AKA-- Putt Putt

Iron Design L.L.C.

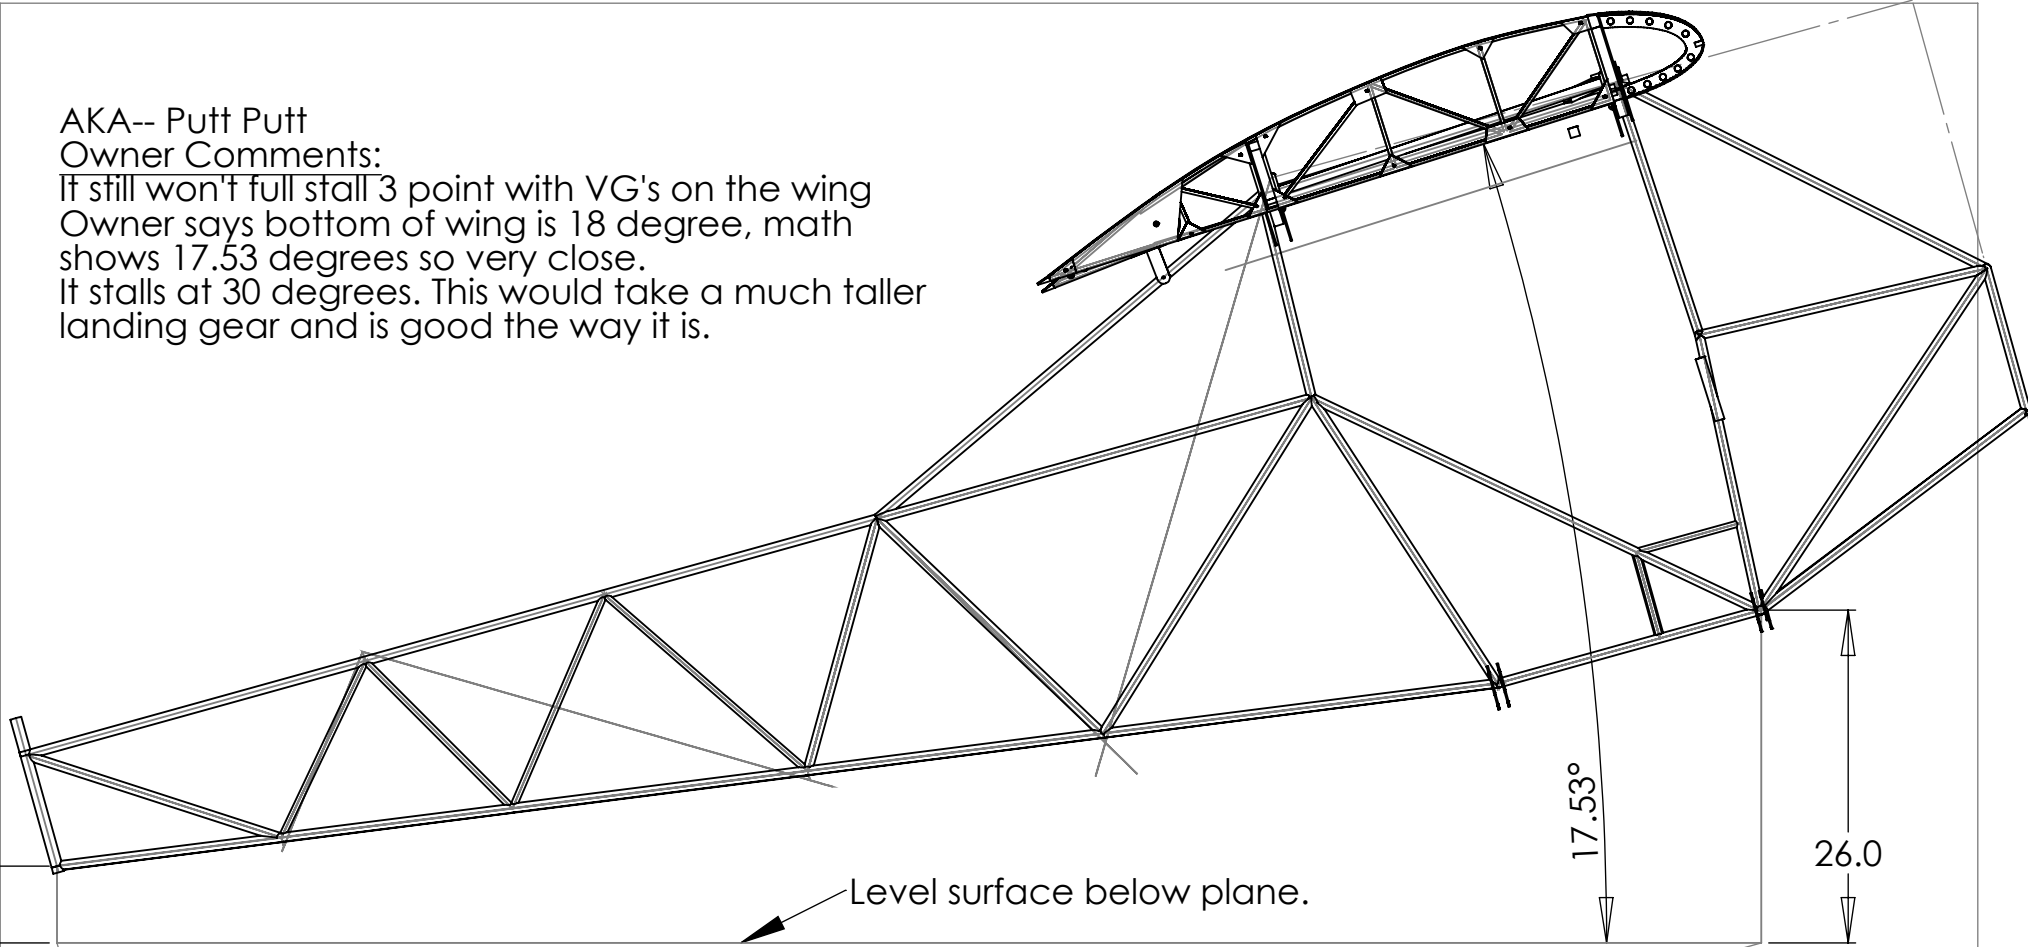
It still won't full stall 3 point with VG's on the wing

Owner says bottom of wing is 18 degree, math shows 17.53 degrees so very close.

It stalls at 30 degrees. This would take a much taller landing gear and is good the way it is.
